Consistency Review Unit New York State Department of State Office of Planning, Development & Community Infrastructure One Commerce Plaza 99 Washington Avenue Albany, NY 12231 CR@dos.ny.gov

Regarding Public Notice F-2023-0287, Hudson Highlands Fjord Trail Inc. ("Breakneck Connector and Bridge")

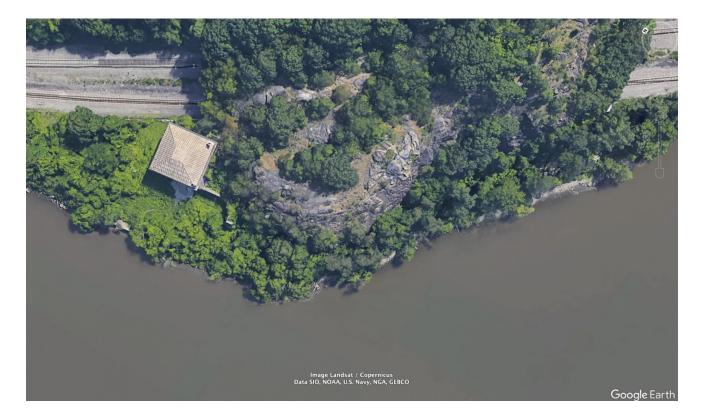
The proposed action includes elements of all three of these activities. In particular, the area just north of the DEP's Hudson River Drainage Chamber, where the shoreline stabilization to support the bridge's construction is proposed, is habitat to numerous species, including several that are endangered or threatened as detailed in the Joint Application, as well as the aquatic vegetation that supports some of them. Additionally, the "Site Protection & Removals Plan 2" shows extensive clearing of trees and vegetation that provide habitat. (Note: The photographs of this area in Attachment 2a were taken in winter at locations strategically selected to make it look like as much of a wasteland as possible. The aerial photograph on the next page shows that much of the area has lush vegetation.)

In *Attachment 1 - Project Description* in the Joint Application, the sections "Bridge" and "Shoreline Stabilization" describe in some detail the extent of disturbance that is required uniquely to support construction of the bridge, which as noted earlier is of highly questionable independent utility. This includes:

- 126 cubic yards of riprap stone armor below spring high water (SHW), as well as an unspecified quantity above SHW.
- A 260 x 60 ft "logistics/mobilization barge" to be moored next to the shoreline for a period of at least 24 months, anchored by 36" diameter spud piles.
- Additional large barges coming in and out transferring equipment, materials, and personnel.
- Compacted stone and steel road plates to provide a 54 x 25 ft ramp with a concrete weight-bearing footing for transferring heavy equipment and materials from the barge to the staging area.

It will be a massive construction site for at least 2 years. The logistics barge, being anchored permanently just offshore, will be subject to storms and ice flows that will cause significant motion and destruction of the river bed where spud piles are located. Any plants, fish, or wildlife in the vicinity of this area will be obliterated by this activity. To claim any impacts are "None or small" and that "the Project will not result in permanent impacts to the river" is simply untrue. Because of significant fish and wildlife in the area, the Department should require a Federal EIS to fully understand and evaluate all of the potential impacts of this activity.
